Subject: Mitigation Plan Addendum for the Upper Silver Creek Restoration Project in Burke
County
Catawba River Basin – CU#03050101-050050
Service Contract No. 003270
DMS No. 94645
Baker Project No. 120598

Upper Silver Creek Stream and Wetland Restoration Project – Mitigation Plan Addendum

Michael Baker Engineering respectfully submits this wetland WMU reclassification as an addendum to the mitigation plan for the Upper Silver Creek Restoration project (DMS Project #94645). The revised table reclassifies 0.42 WMUs from riparian to non-riparian wetlands.

Figure 2: The revised mitigation plan addendum wetland asset map

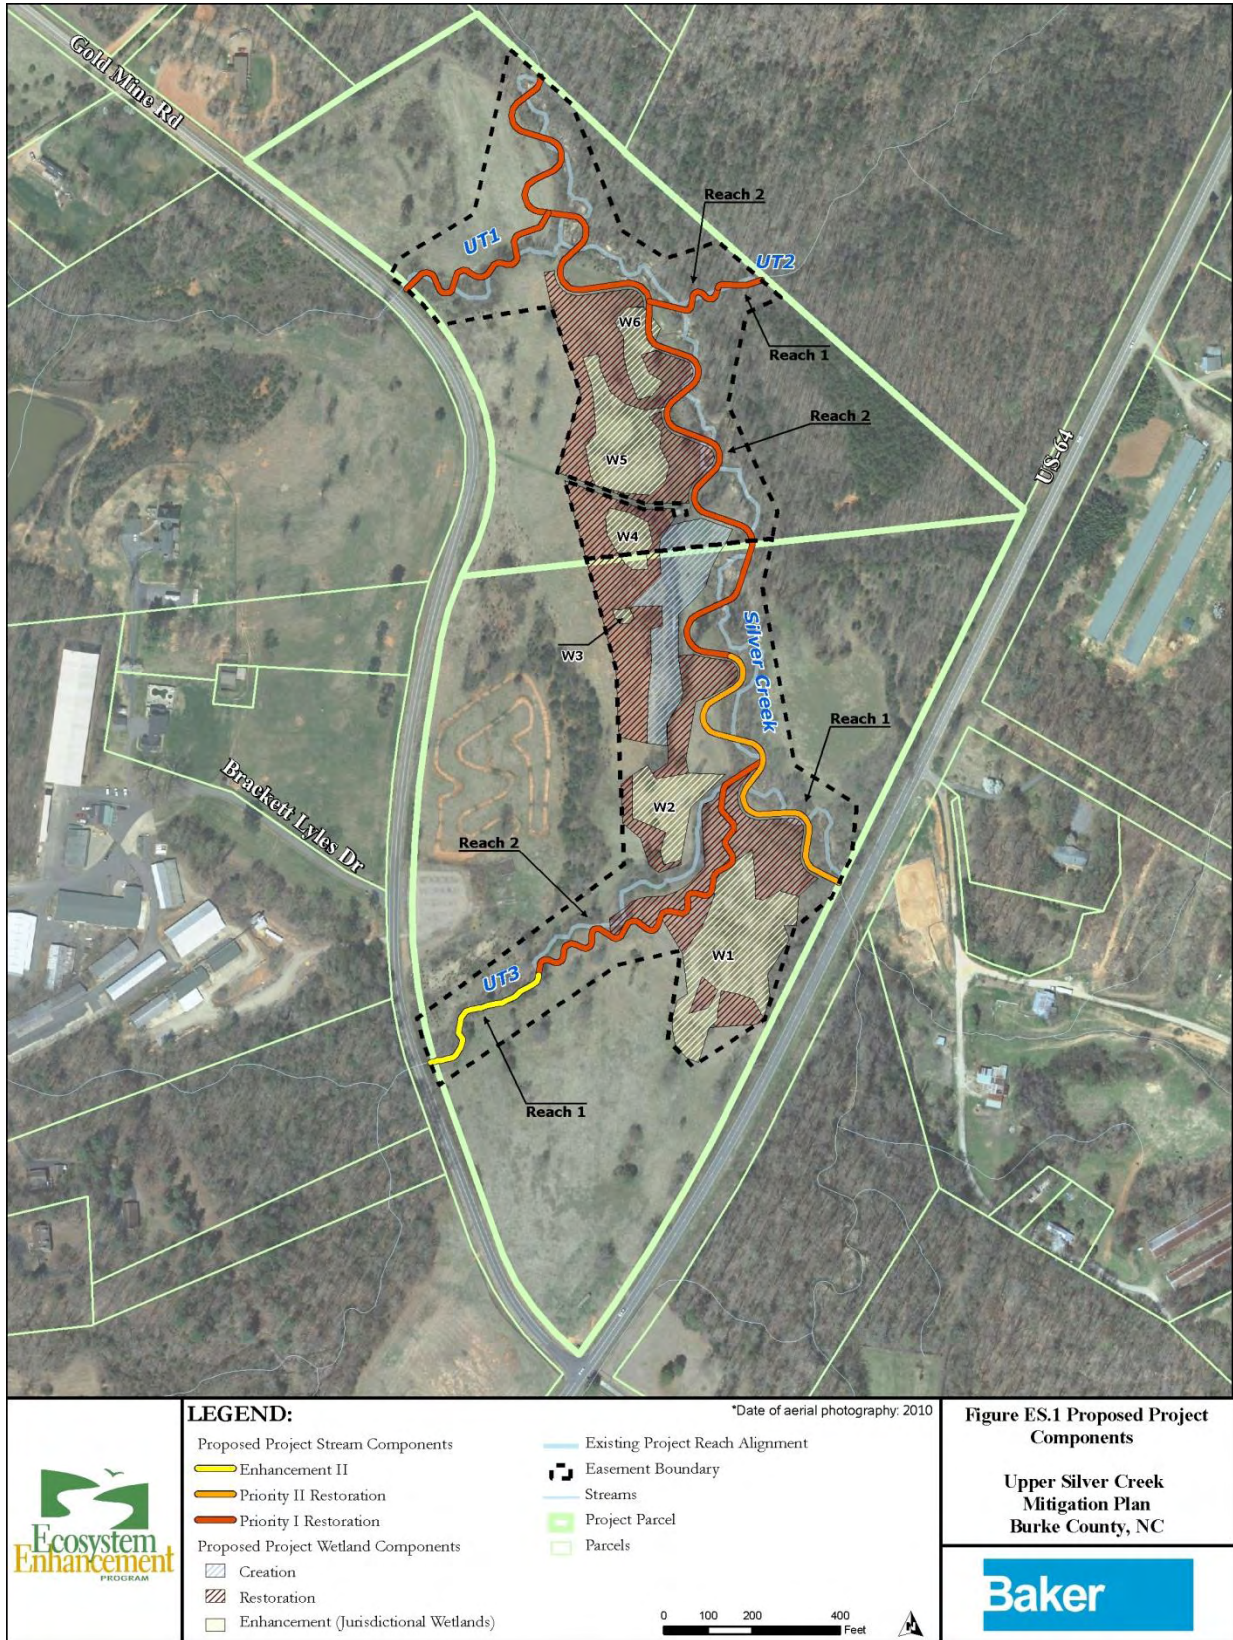
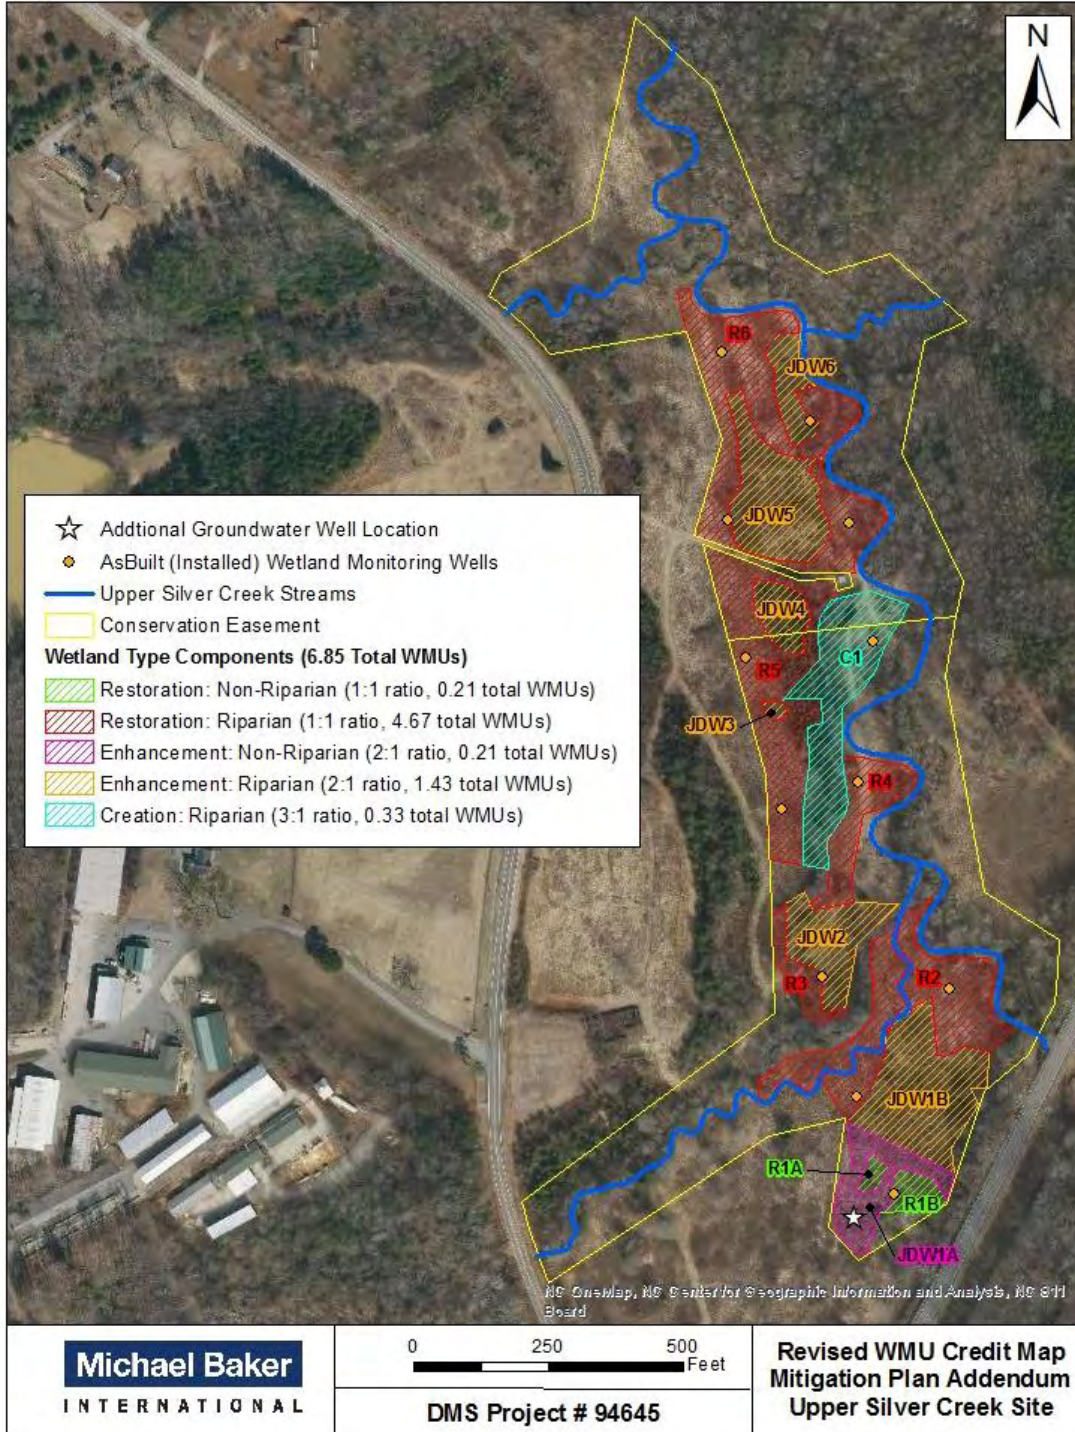
On October 26, 2015, Baker personnel met on site with representatives from the Corps of Engineers, NC Division of Water Resources, and NC Division of Mitigation Services to inspect existing wetland mitigation areas proposed for reclassification from riparian to non-riparian. After discussion, it was determined that the wetland area located within a seep along a slope in the southwestern portion of the project was located outside of the geomorphic floodplain and acceptable for reclassification (see Figure 2). Currently the wetland area is classified as predominantly Riparian Wetland Enhancement (JDW1A) at a 2:1 credit ratio for 0.21 WMUs, with two pockets of Riparian Wetland Restoration (areas R1A and R1B) at a 1:1 credit ratio for 0.21 WMUs. This addendum simply reclassifies those WMUs as Non-Riparian (see Table ES.2.Rev).

During the field investigation Baker also agreed to install an additional monitoring well in the newly reclassified non-riparian wetland area (see Figure 2). It will be installed in the upper portion of the wetland enhancement area over the winter 2015 before the growing season begins in 2016 to capture groundwater data for Monitoring Year 2 onward. The existing monitoring well located in this non-riparian area was installed in one of the wetland restoration areas. Thus this non-riparian wetland area will have two groundwater monitoring wells located within it.

Additionally, during the GIS analysis conducted to reclassify and revise the WMUs for the project, two errors were discovered in the original mitigation plan calculations of the acreage for the R4 and R5 riparian wetland areas proposed for restoration. The acreage for R4 was reported as 0.62 ac but is actually 0.44 ac, while the acreage for R5 was reported as 1.53 ac but is actually 1.29 ac. These errors subsequently resulted in the miscalculation of the total WMUs for the project, with a mistaken reported overage of 0.41 WMUs. The corrected WMU values are reflected in the revised asset Table ES.2.Rev.
